TRIM: FW: Air Amb Supp [SEC=IN-CONFIDENCE:AUDIT]

Some preliminary results for the accident flight using a more sophisticated and operationally validated biomathematical model (SAFE).

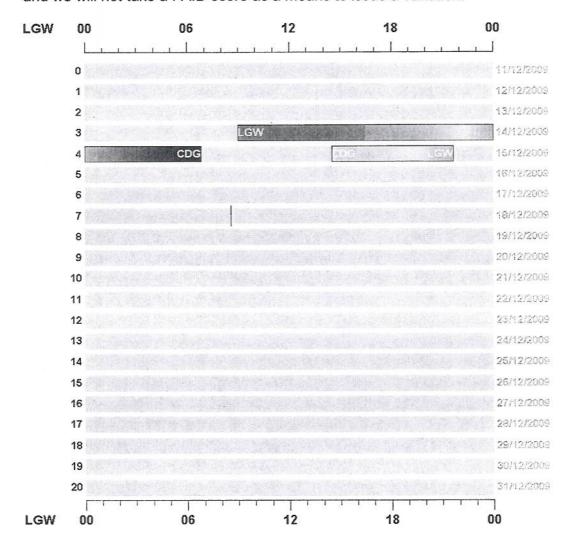
The end of the first flight has a Samn-Perelli alertness score of 5.7 (we use 5 as a our max baseline but would expect to see 5.1 / 5.2 after a long night flight). The blood alcohol level is 0.140%, which is one and half times our drink drive limit.

The second flight ends on a score of 0.059% blood alcohol and a Samn-Perelli score of 4.4, this is assuming that the crew got a good quality 5 hours of sleep on the day stop. We would not allow such a pattern and in this case I would say that the scores are on the low side for the second flight, especially as you can see that the rest period did not allow a the crew to fully recover from their previous duty (the yellow/green colour indicates this).

We have had issues where FAID scores have been very different from SAFE scores and we will not take a FAID score as a means to issue a variation.
